# Final Environmental Assessment of the Test Bed Initiative Demonstration

**March 2023**

**APPENDIX B: COMMENT RESPONSE DOCUMENT**

**Figure 1-1 Hanford Site Map**

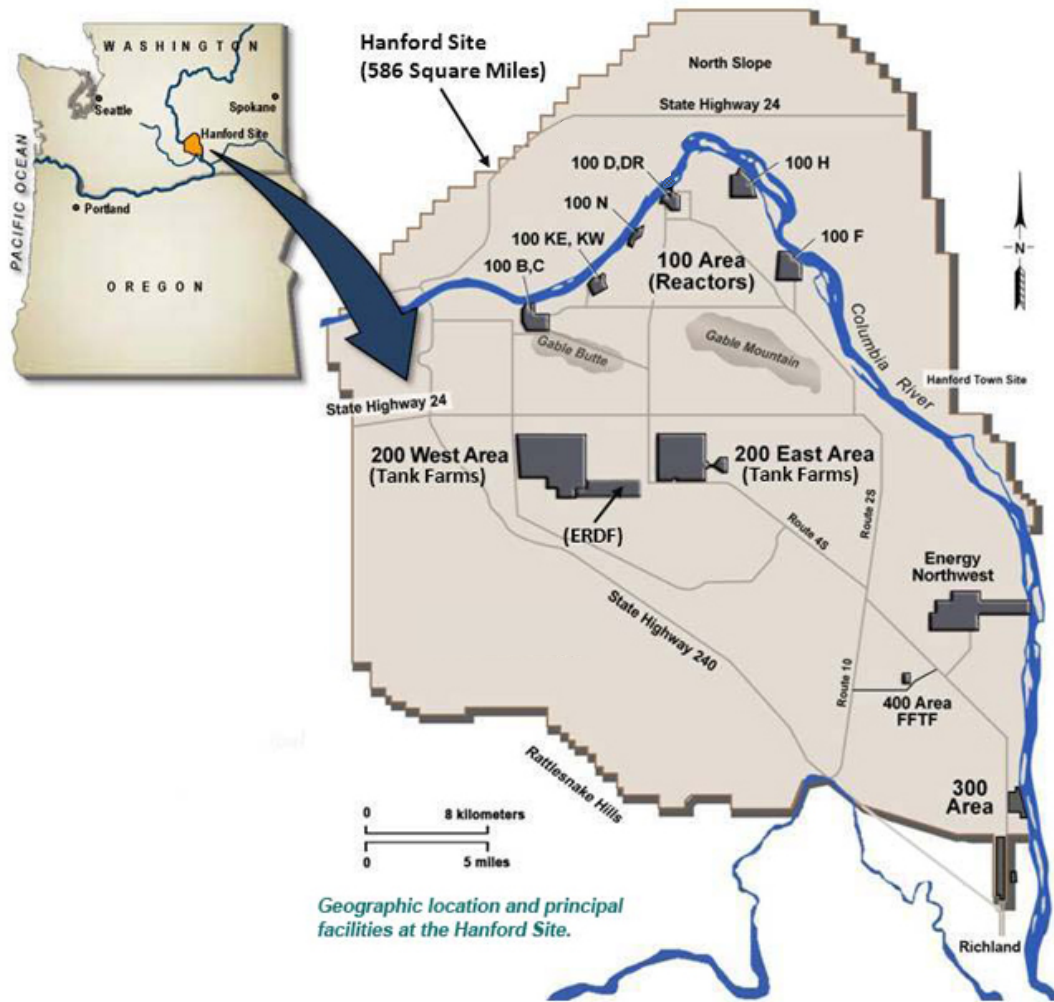
The Hanford Site map provided in Figure 1-1 is old and poor quality. Please replace with a more current higher quality figure.

Figure 1-1 has been replaced.
